CITY OF ALBUQUERQUE

RE: **Premier M.H Display Yard**
Grading Plan
Engineer's Stamp Date 8/4/17
Hydrology File: M14D012C2

Based on the information provided in the submittal received on 8/7/17 the above-referenced Grading Plan cannot be approved for Building Permit until the following are addressed:

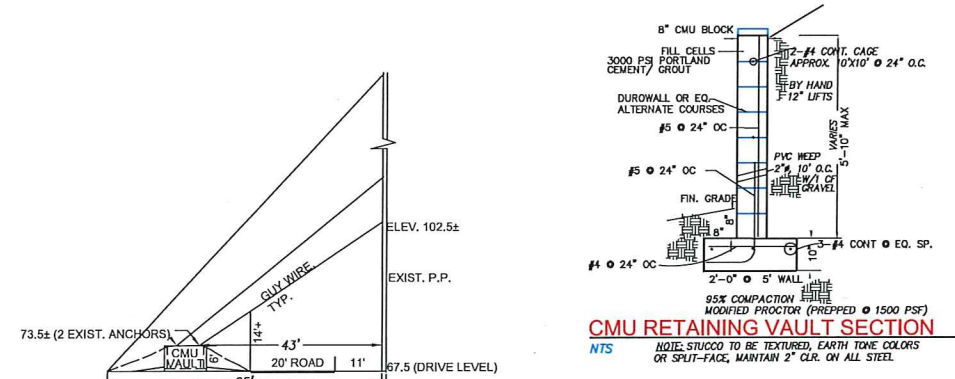
4. Offsite basins, lot 1A-1, must be clearly shown on the plan (or on a separate basin map) using a base map that includes property lines contours, and all storm drains, roads, C&G, ditches, and berms as necessary to support the chosen location of the basin boundaries. Flow arrows should be shown on the map indicating concentrated flow paths especially at the point of discharge from each of the basins.

must be retained onsite including the runoff from lot 1A-1 east of this site. Runoff from the slopes on the south and west sides of the site should also be retained. The emergency overflow spillway needs to be sized to pass the peak inflow with 1' of freeboard,

13. Written approval must be obtained from the owners of lot 1A-2 to remove their wall.
14. The new driveway entrance off San Jose cannot be placed over the transition slab for the existing inlet. The d

X-SECTION FOR PNM
SCALE: 1" = 20'

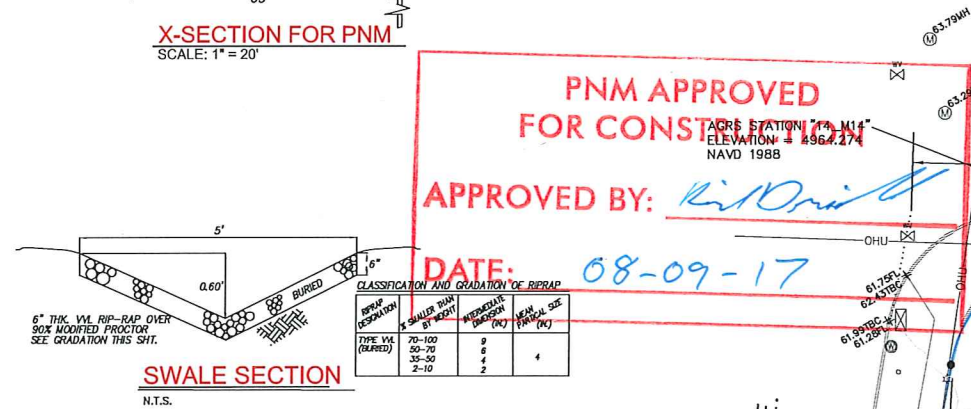
11. A Drainage Covenant will be required for the new pond.
12. Written approval must be obtained from PNM to move their guy wires and work in their easement.
